PJM Manual 12: Balancing Operations

Revision: 37

Revision 37 (xx/xx/2017)

- [Revisions to Section 3.1.2 PJM Control Implementation and Section 4: Providing Ancillary Services: Incorporation of RMISTF Solution Package](#)

Exhibit 1: PJM Regulation Signals

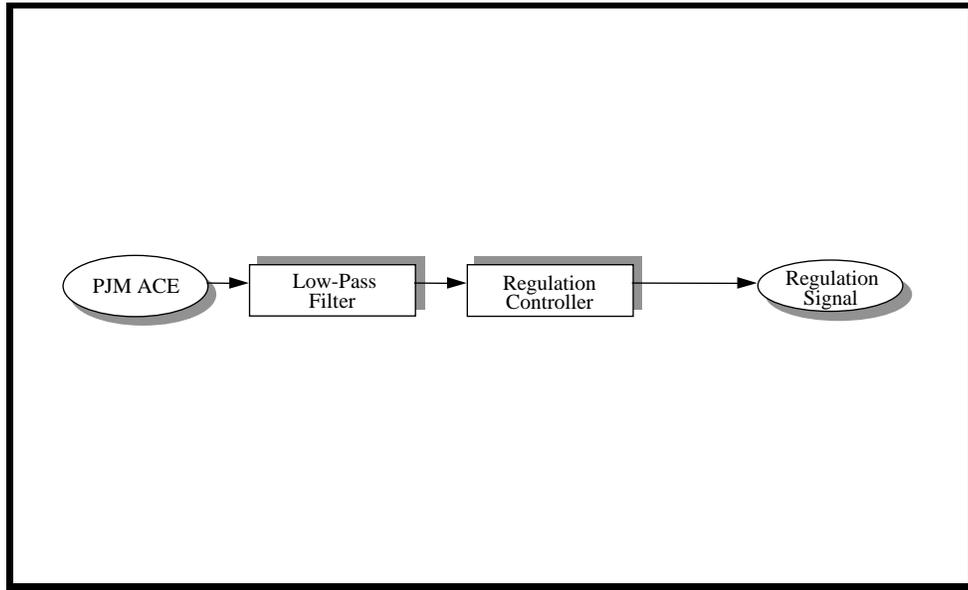
- o RegA- is the low-pass filter of the regulation control signal, developed with consideration to minimize accelerated ramp rate, sent to traditional regulating resources
- o RegD- is the residual of the regulation control signal, developed with consideration to minimize net energy demands, sent to dynamic regulating resources

Regulation signals are currently constructed with a 30 minute conditional neutrality bias that calculates an offset to the RegA signal, when headroom is available to help manage state of charge for RegD resources.

- ~~RegA- low pass filter of ACE for traditional regulating resources, and,~~
- ~~RegD- high pass filter of ACE for dynamic or fast response resources~~
